Photographs in Support of Wil Arnett Declaration

Submitted in Support of Oncor Electric Delivery Company's Reply Comments

April 22, 2008

Violations CATV / ILEC

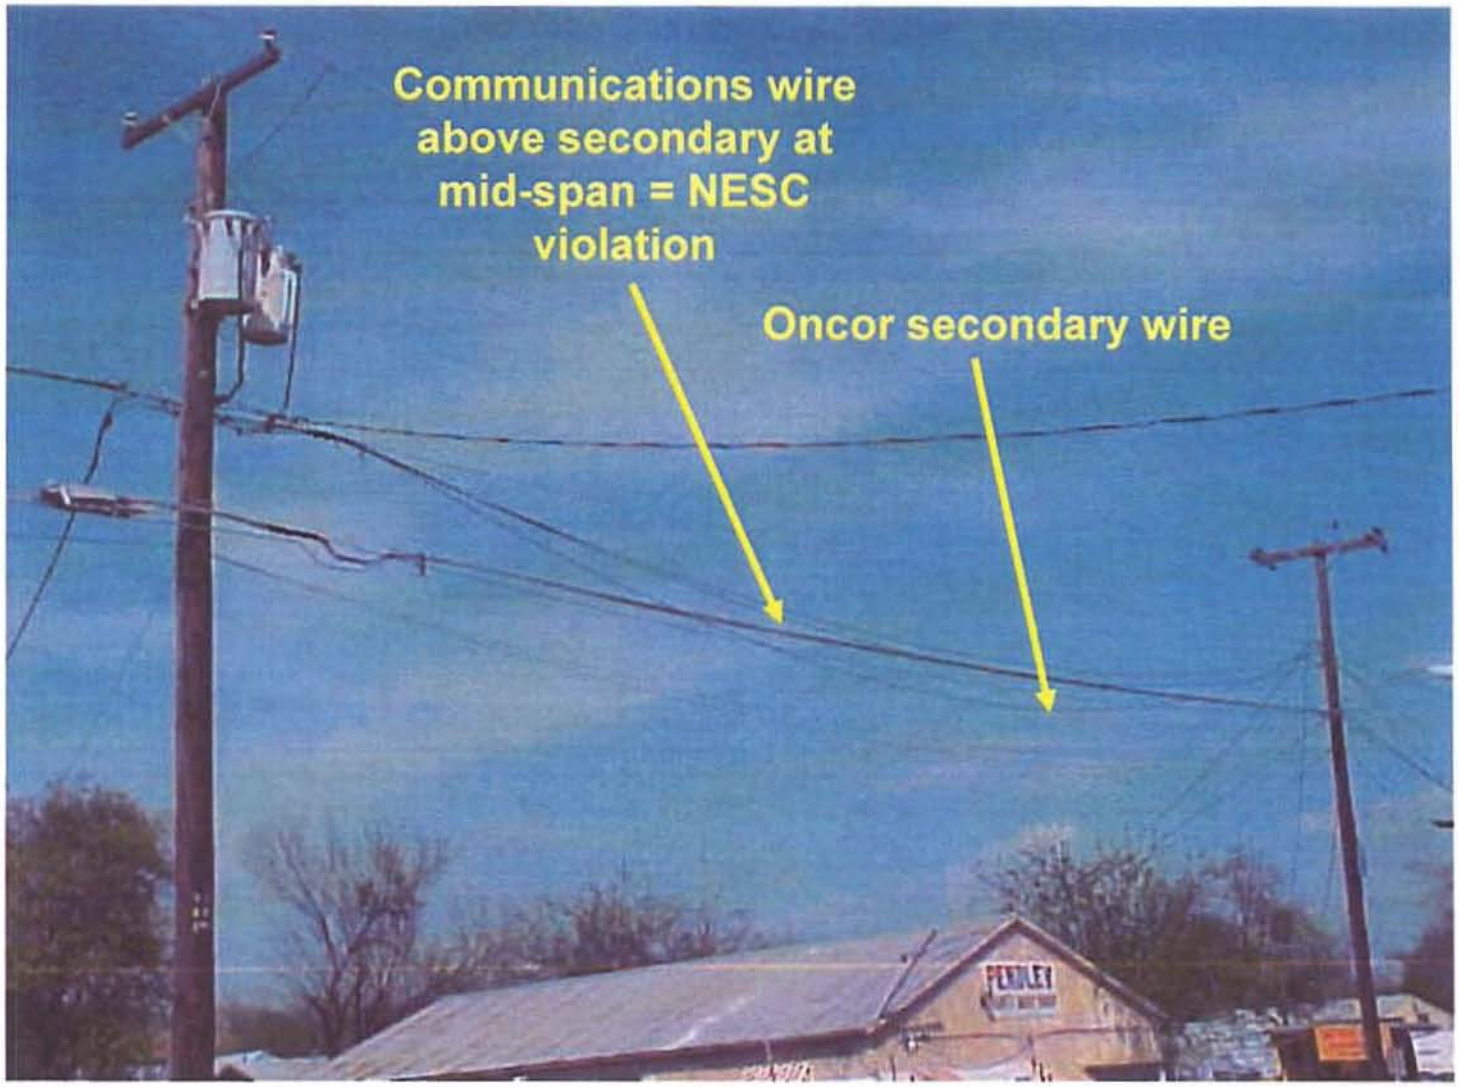
Communications wire above secondary at mid-span = NESC violation
Oncor secondary wire

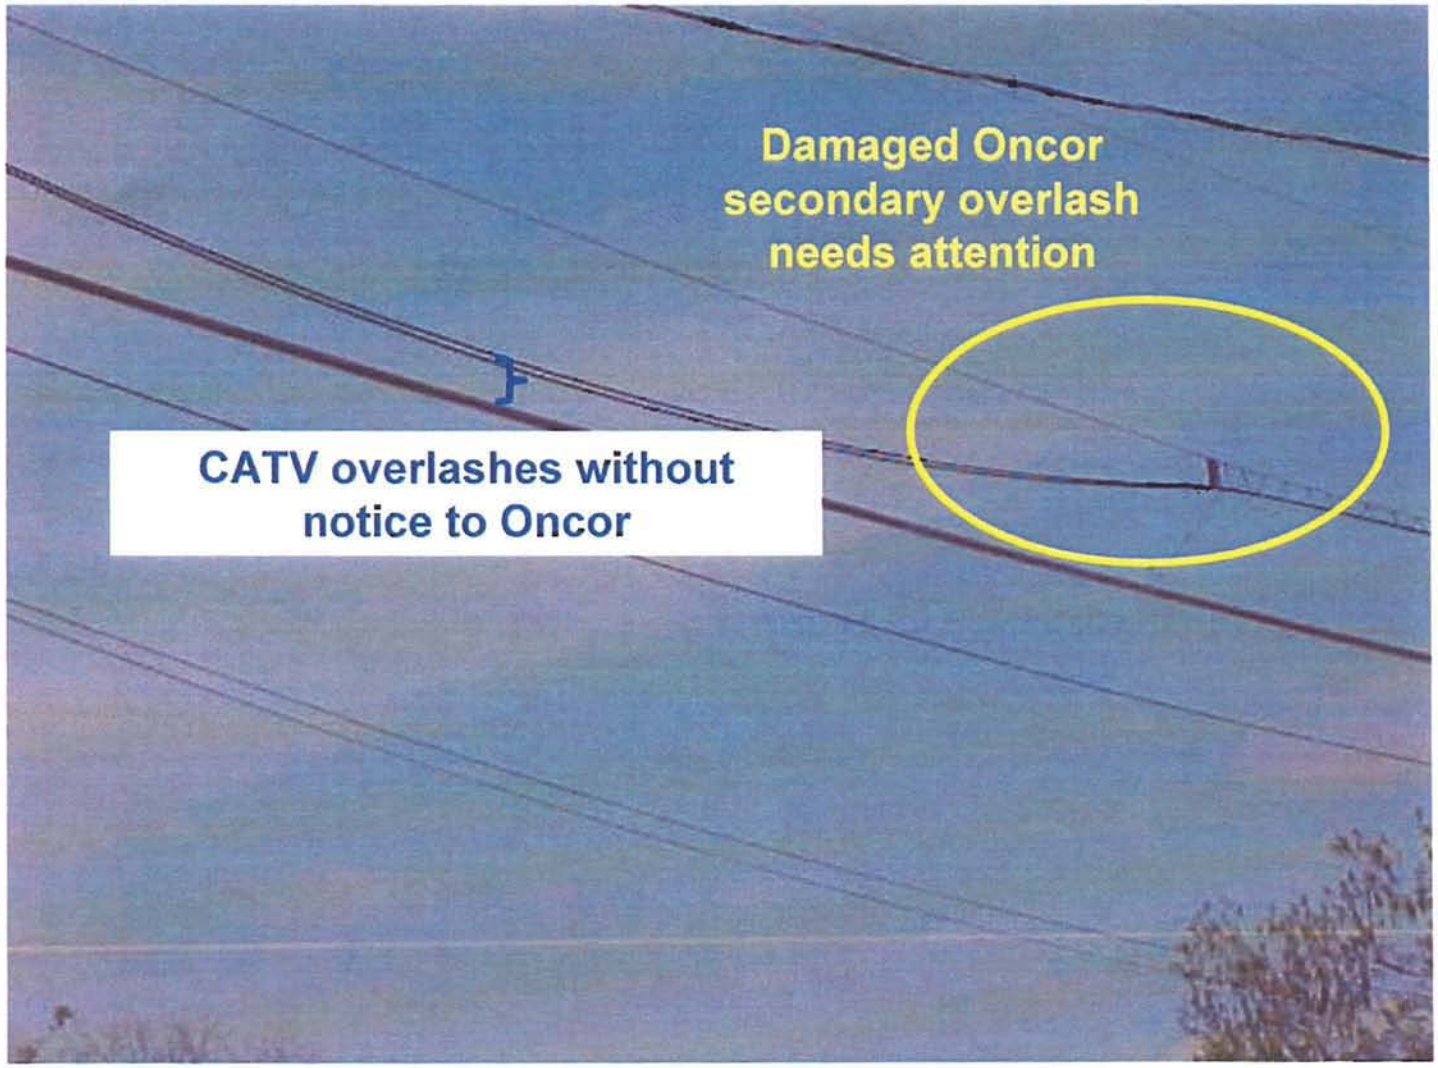
Damaged Oncor
secondary overlash
needs attention
CATV overlashes without
notice to Oncor

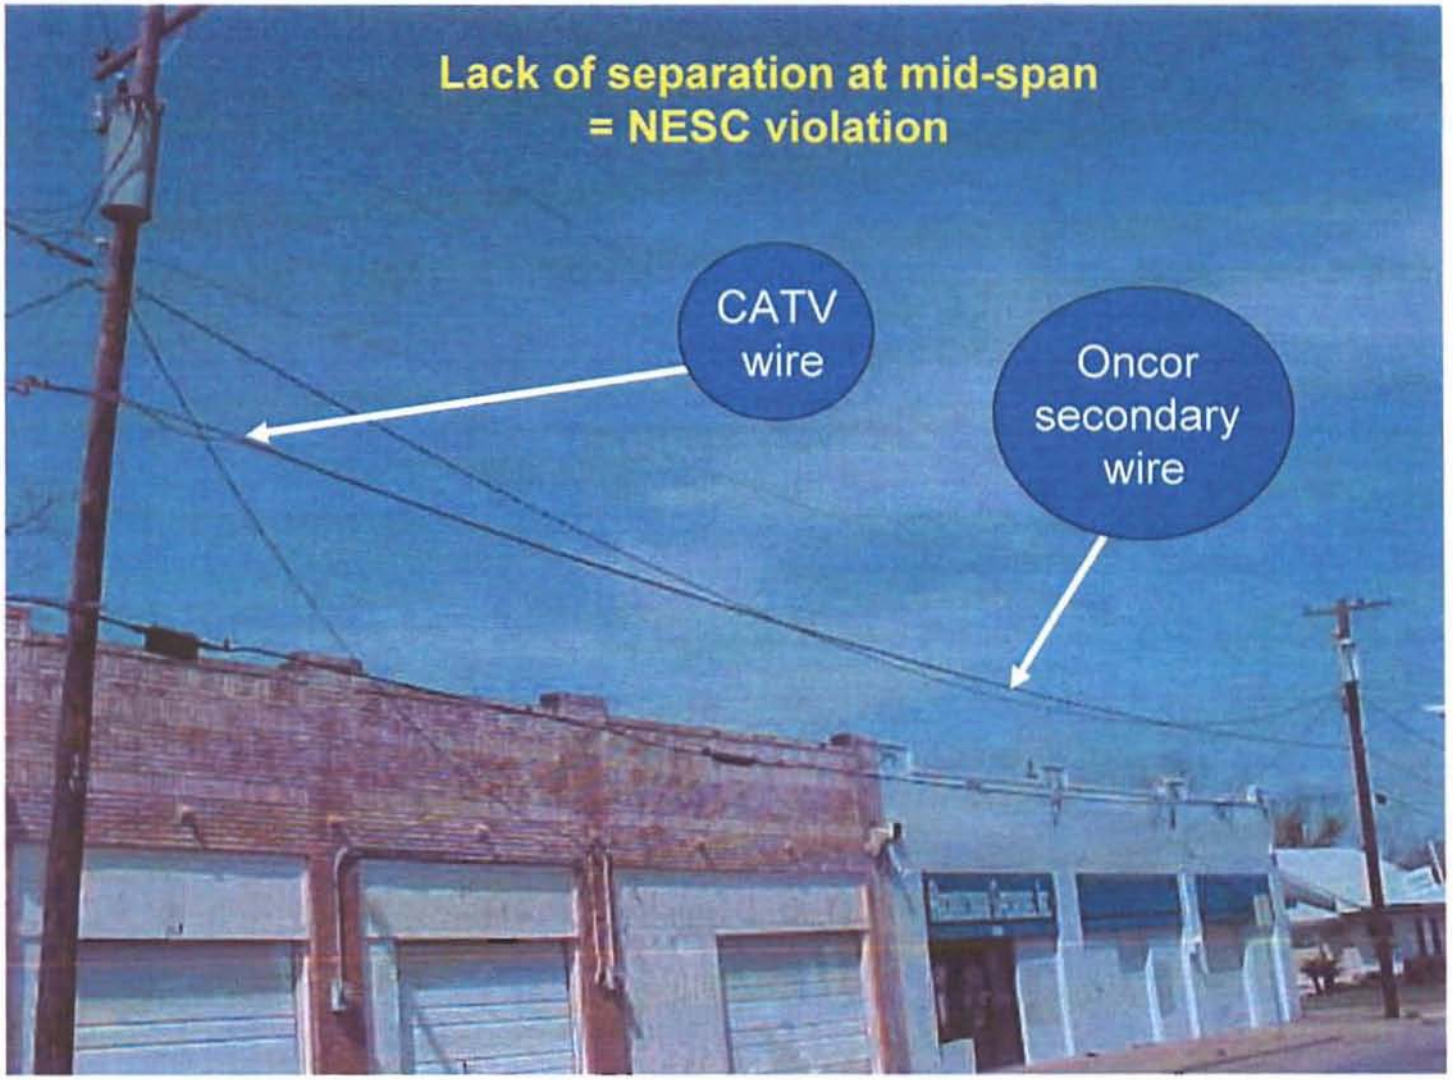
Lack of separation at mid-span
= NESC violation
CATV wire
Oncor secondary wire

Overlashing = Real burden on pole

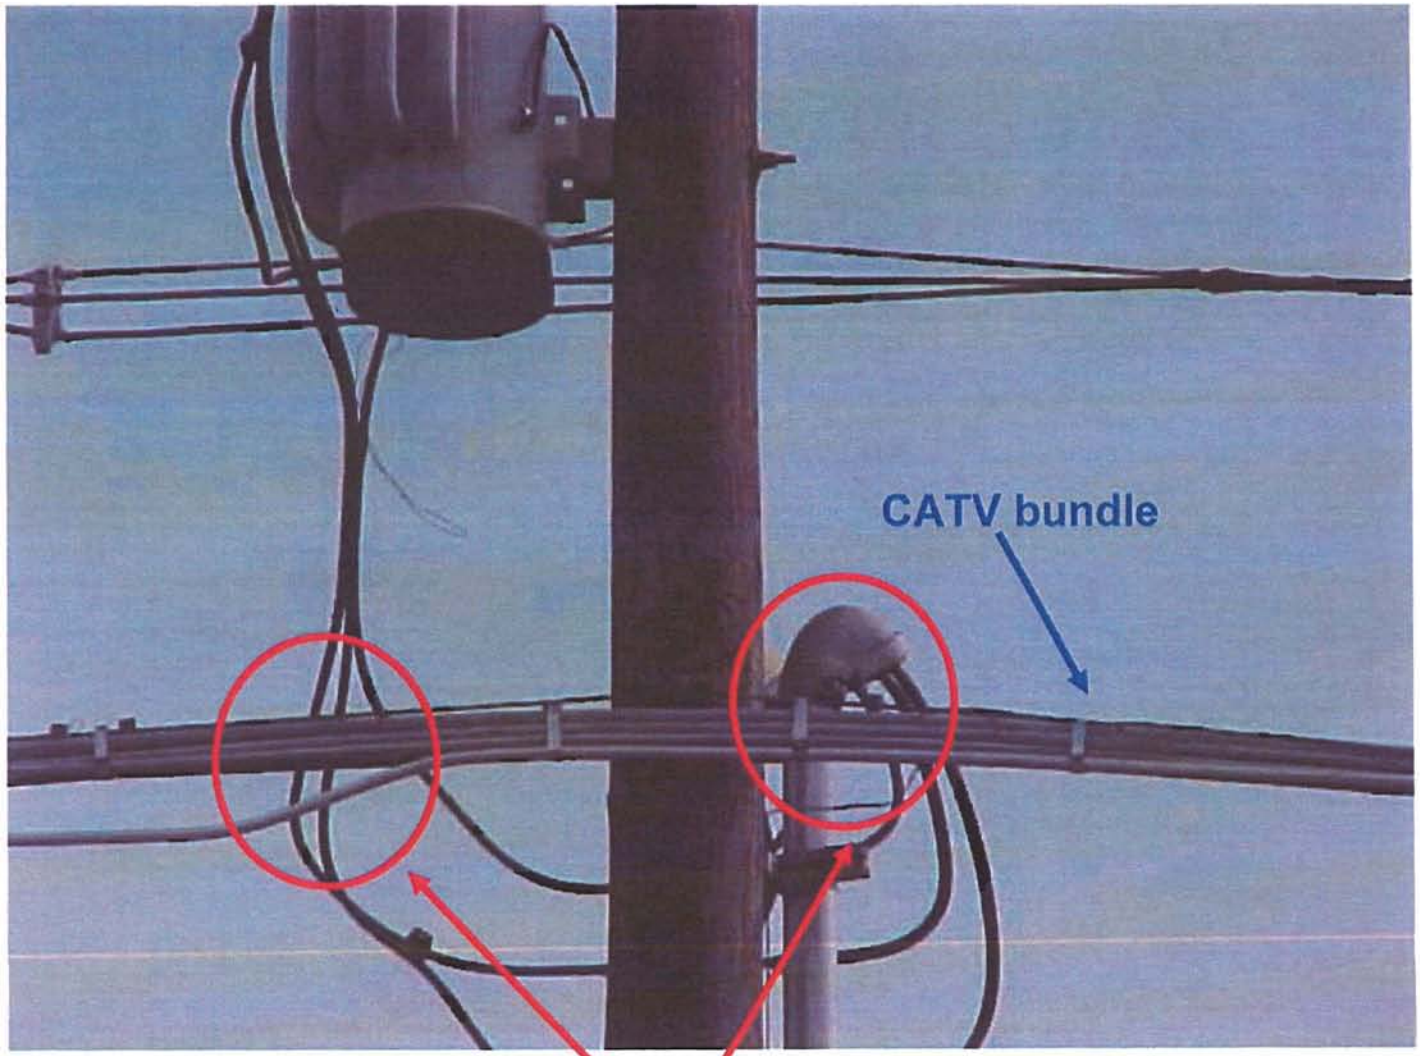
No separation from power facilities = NESC violatoin
